SERVICE BULLETIN

BULLETIN # 07-04
DATE: 7/07/2004
SUBJECT: 48 CONVERTIBLE
Generator Fuel line
HULL #s: #31 to #60

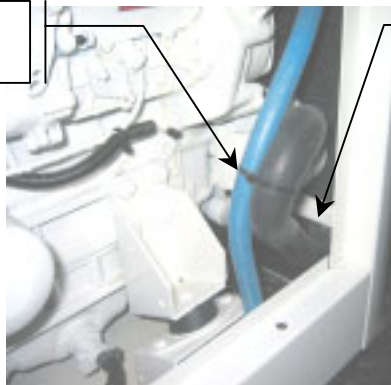
It has recently come to our attention the fuel return line from the generator may come in contact with the Belt-Pulley system on the front of the generator engine. This contact will cause severe damage to the fuel line, resulting in a major fuel leak.

MOVE FUEL LINE HERE, AND SECURE WITH WIRE-TIE

ORIGINAL FUEL LINE LOCATION

1. Remove the aft side generator hush cover panel.
2. Move the blue fuel hose to the location shown in Figure 1.
3. Secure the fuel line to the generator cooling hose with a small wire-tie. Do not over tighten the wire-tie, or damage to the cooling line may occur. The fuel line does not need to be disconnected during this process; there is sufficient slack in the fuel line.
4. Reinstall the generator hush-cover panel.
